MONITORING YEAR 1 ANNUAL REPORT

LONE HICKORY MITIGATION SITE

RE: Lone Hickory Mitigation Site – Monitoring Year 1 Report Final
Yadkin River Basin – CU# 03040101 – Yadkin County
DMS Project ID No. 97135
Contract # 006897

Wildlands Engineering, Inc. (Wildlands) has reviewed the Division of Mitigation Services (DMS) comments from the Draft Monitoring Year (MY) 1 report for the Lone Hickory Mitigation Site. Wildlands' responses to DMS' report comments are noted below in *italics*.

Groundwater Gage Plots

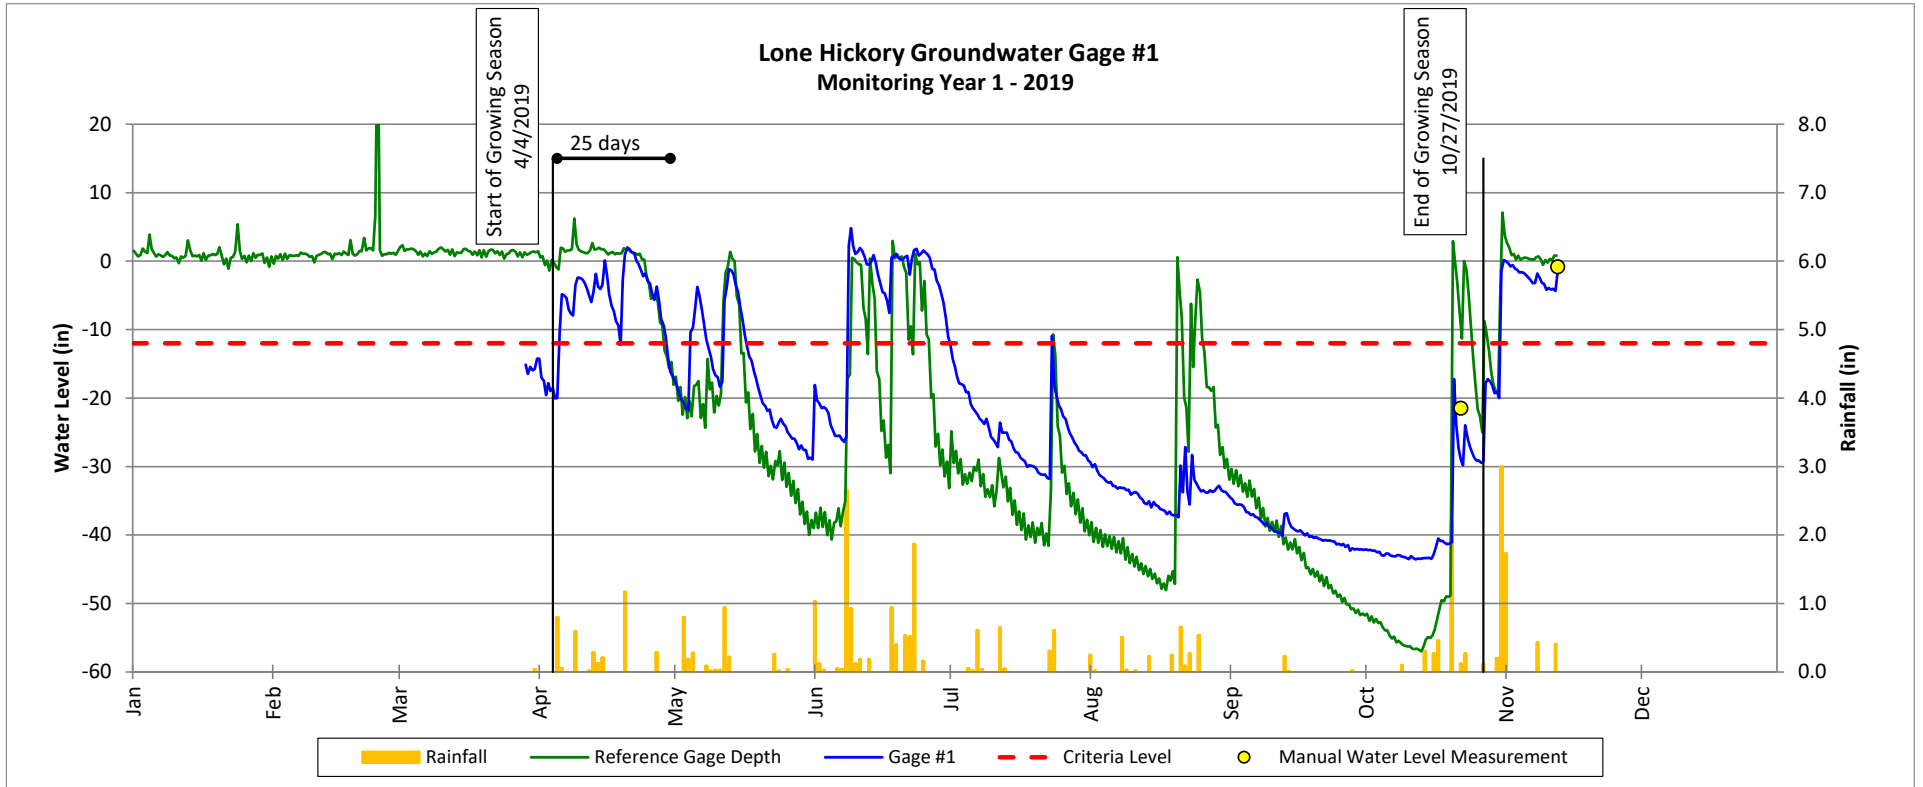
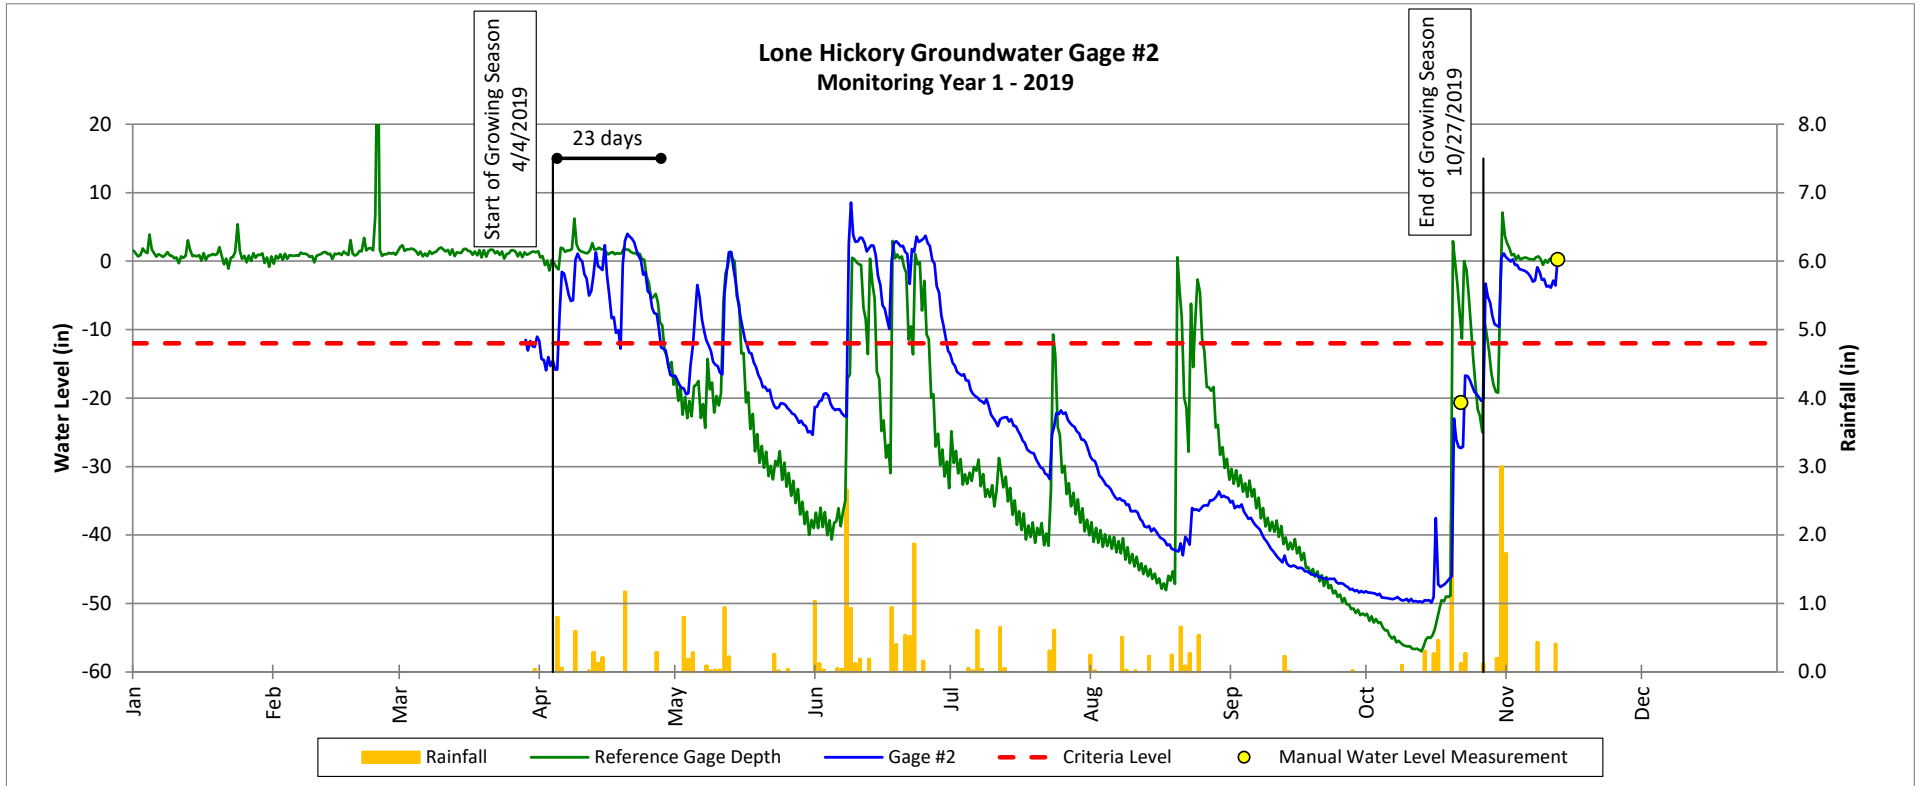
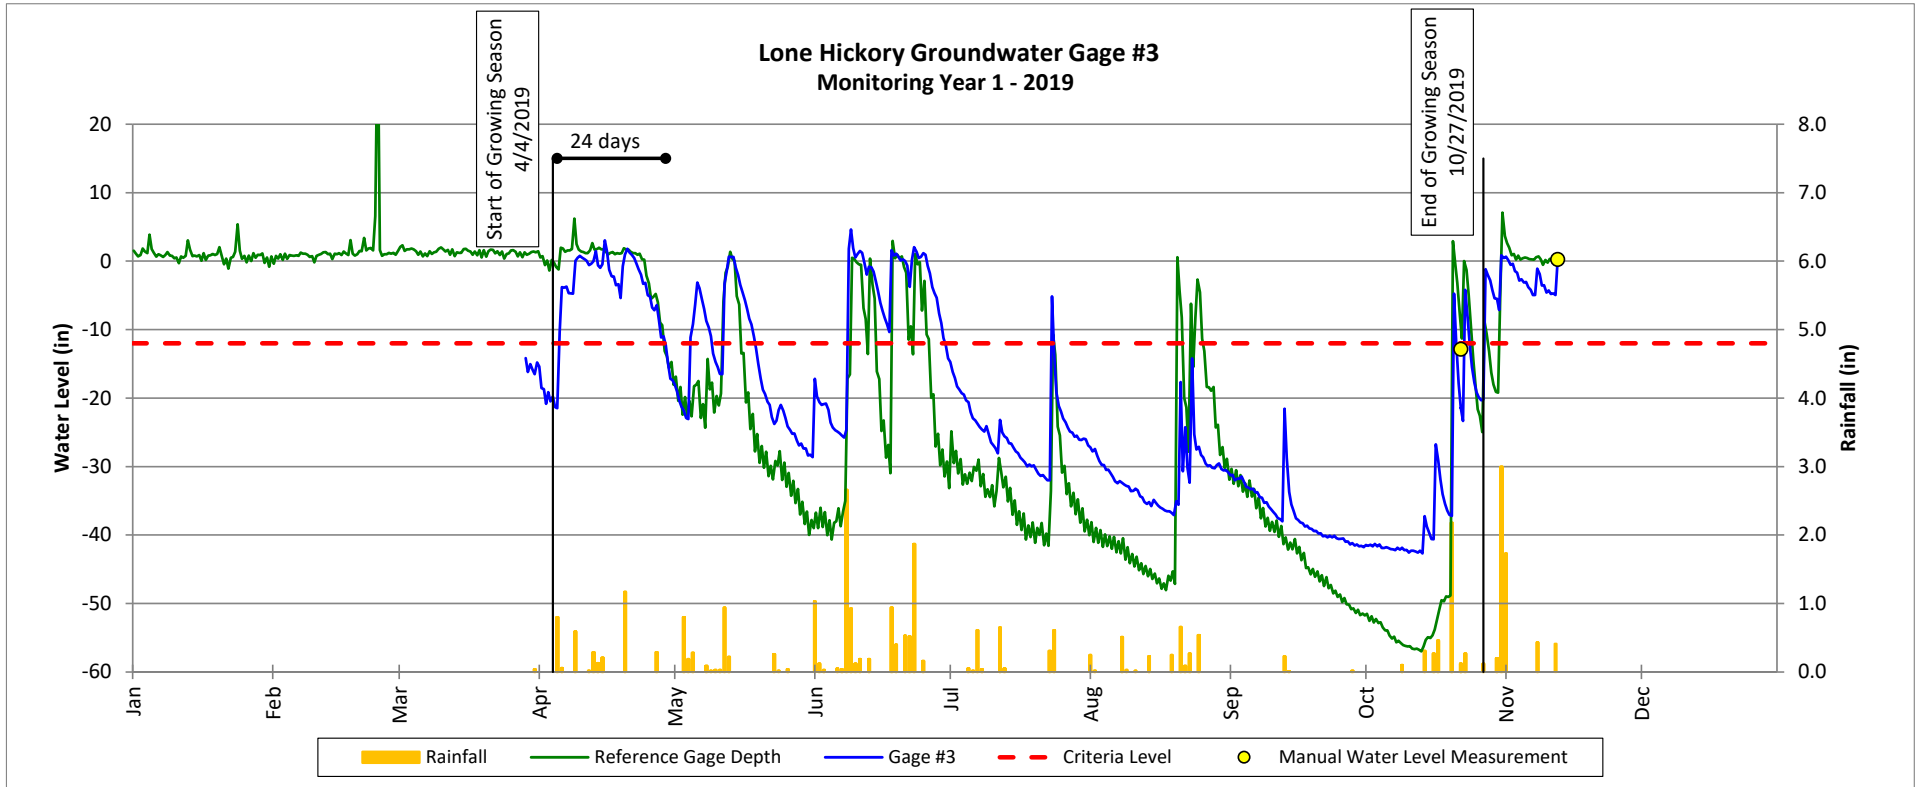
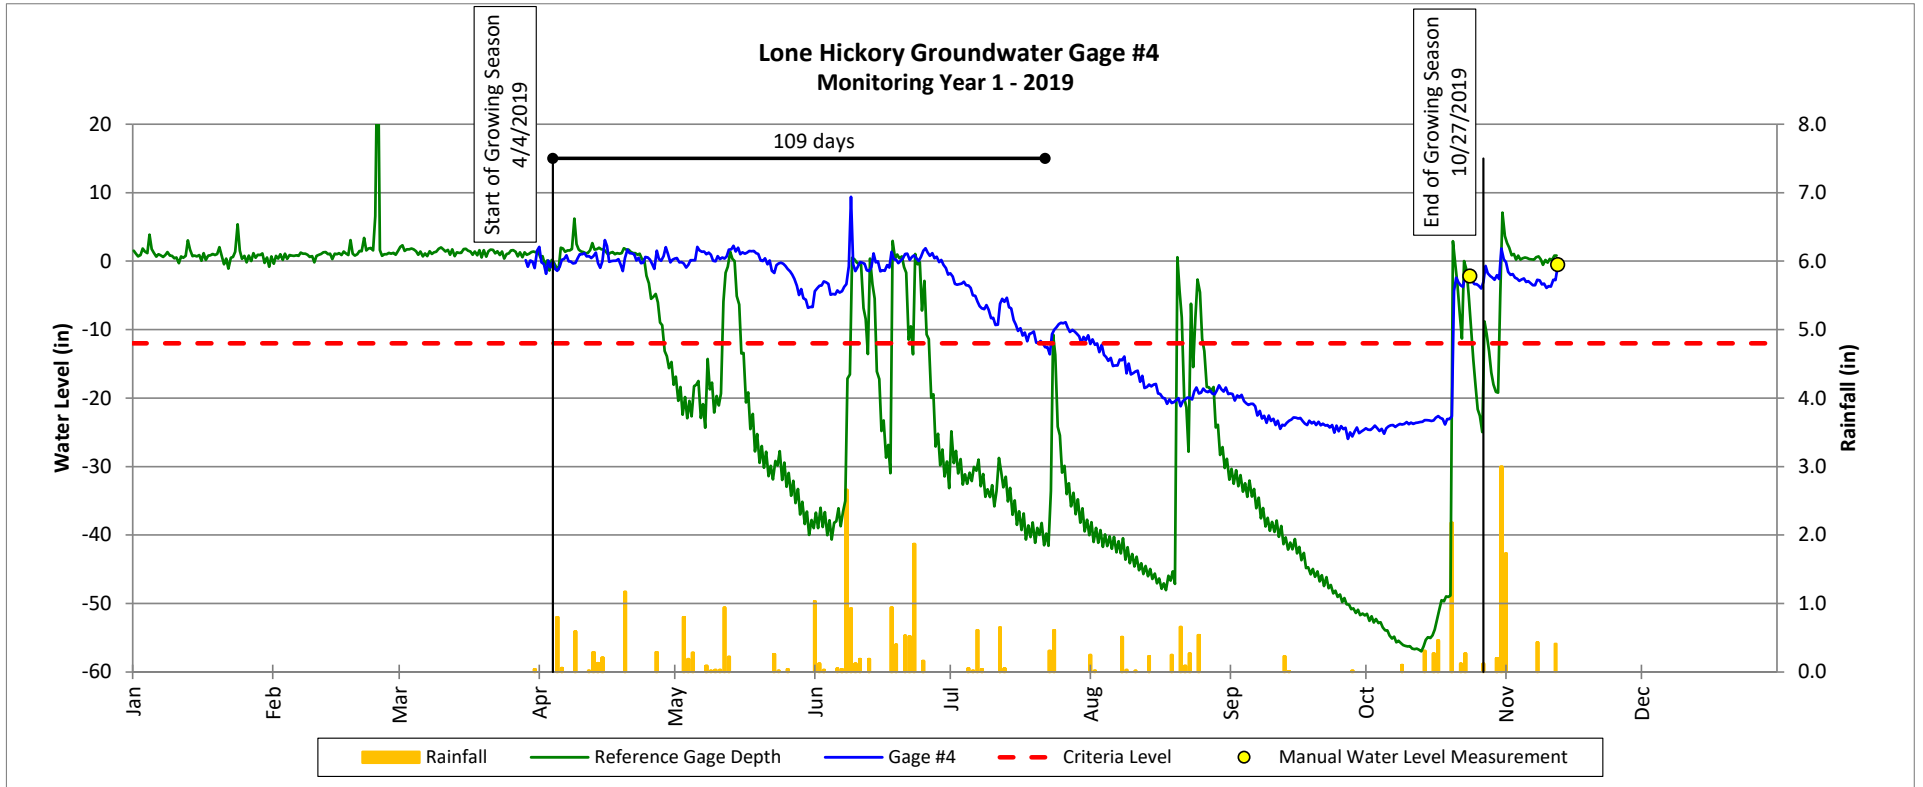
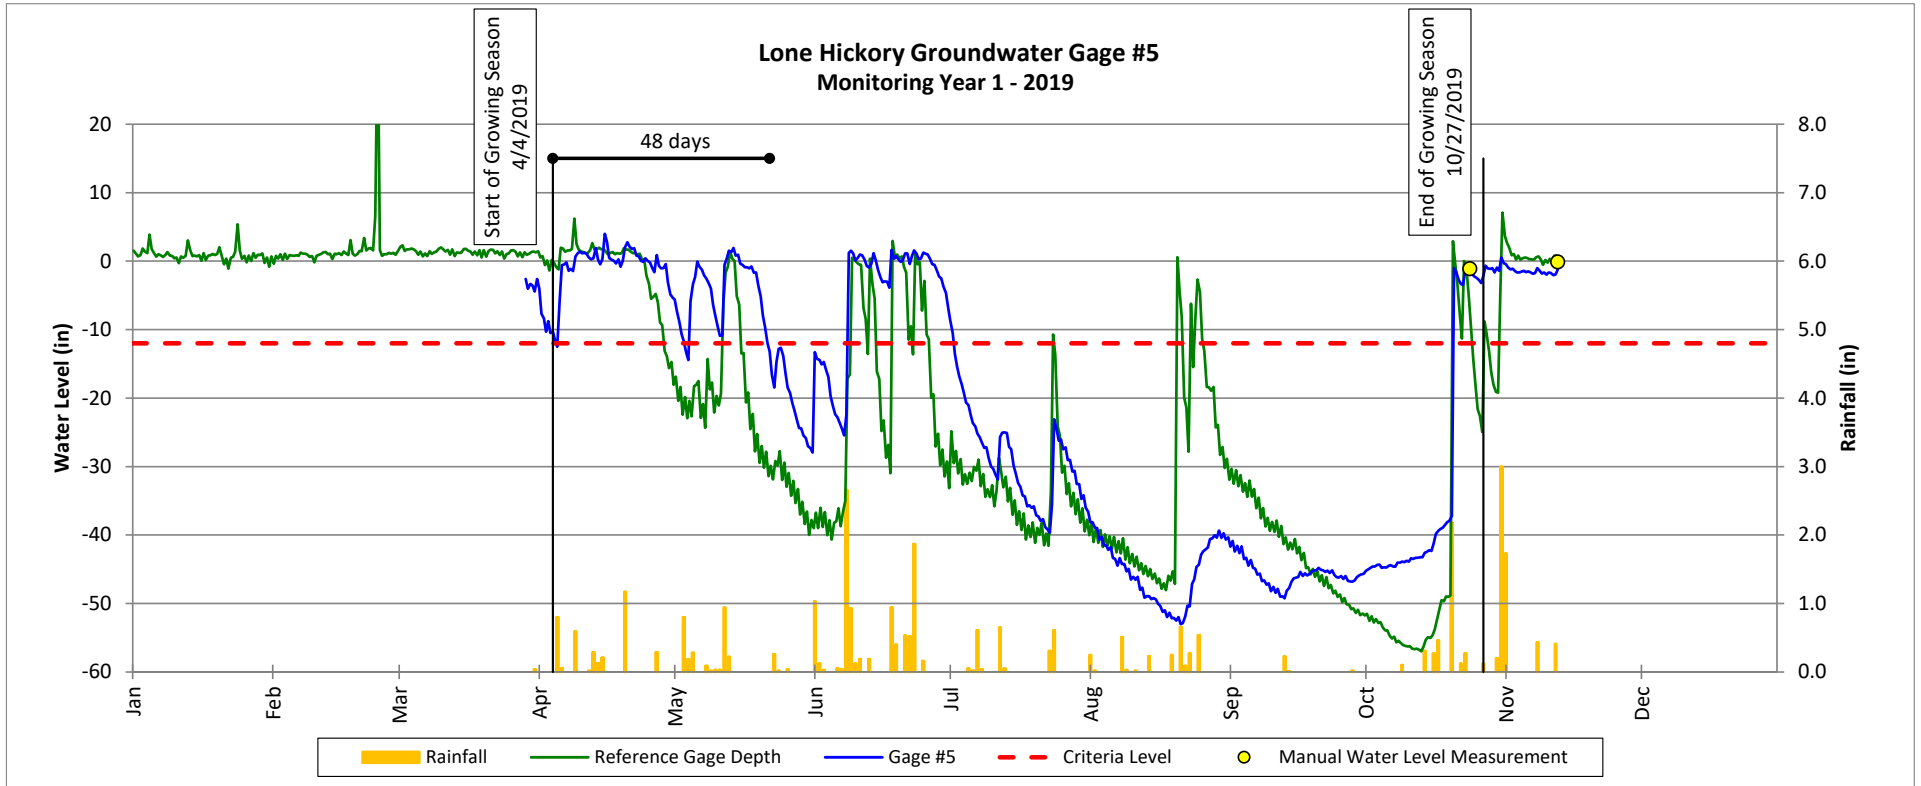
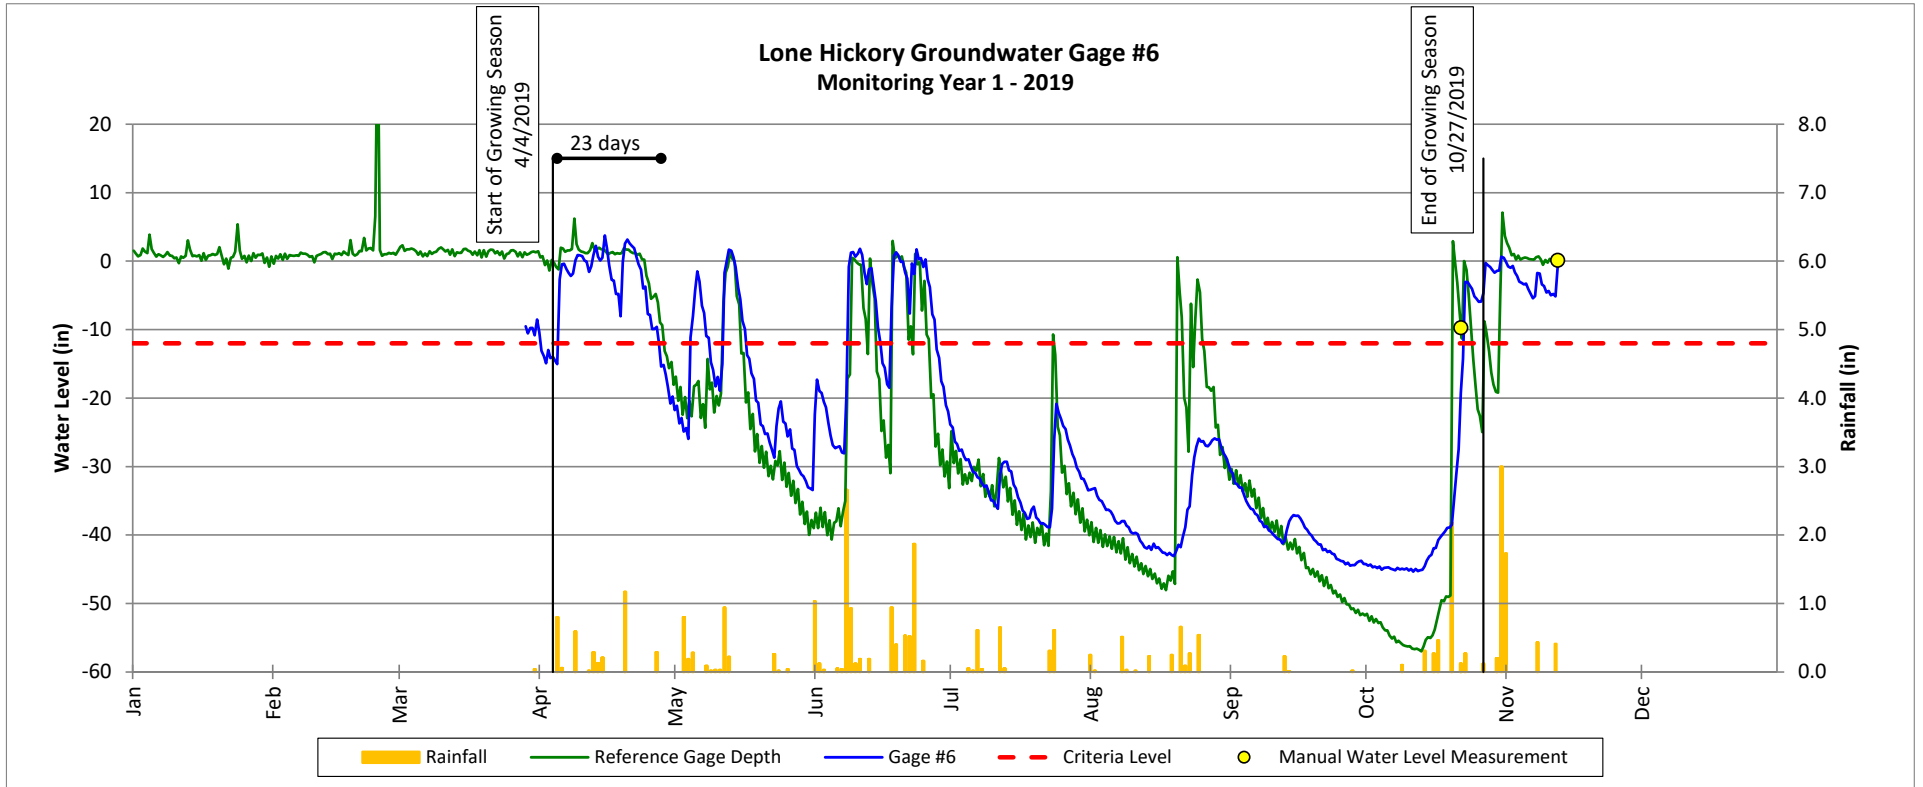
DMS comment; Groundwater gage plots: For clarity, consider adding the consecutive day number for each gage on the groundwater gage plots instead of using the currently shown 19-day bar. The 19-day bar adds some confusion to the plots without a description of what it corresponds too (9.2% of the growing season).

Wildlands response; For clarity, the maximum number of consecutive days achieved by each gage has been added to all groundwater gage plots instead of the 19-day bar.
